**Re: Further Development Application for Ummerra Gravel Pit
Ummerra County Cork
For Drimoleague Concrete Works Limited
ABP Case Number: ABP-308194-20**

On behalf of Drimoleague Concrete Works Ltd (DCWL), please find attached its response to Cork County Council's submission on the Further Development application for Ummerra Gravel Pit. This response addresses the further information sought by the Council and the Council's suggested planning conditions. It is noted that the 10-page Council submission provided to me does not have any assessment reports and appears to rely on the reports relating to the Substitute Consent application. It is noted that there is some cross over in the internal Council's reports between the Substitute Consent and Section 37L Further Development applications. We have provided a response to the Council's submission on the Substitute Consent application under separate cover.

Illustration of Check Dams / Silt Traps

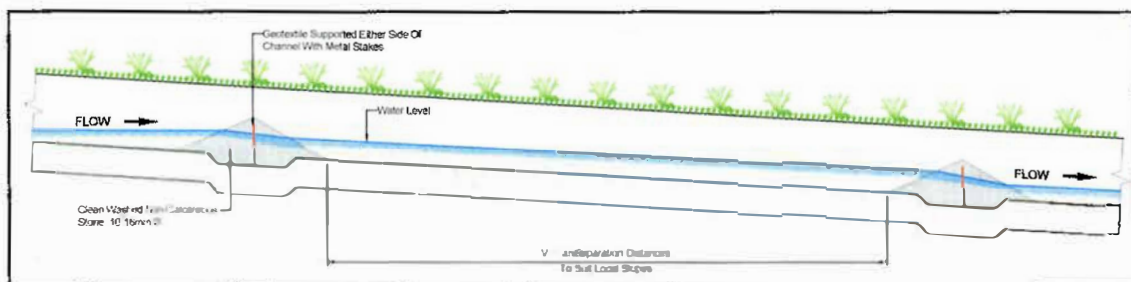
Surface water runoff is diverted to the overflow settlement pond where levels allow. However, the section of access road nearest the site entrance is below the pond, so flow can't be diverted to it. Check dams will be installed along the roadside drainage channel to slow flows and filter the water. These will be constructed using geotextile supported by metal pegs, sandwiched by clean washed filter gravel, as illustrated. The check dams will be spaced so that the toe of one is at the same level as the crest of the subsequent downgradient one.
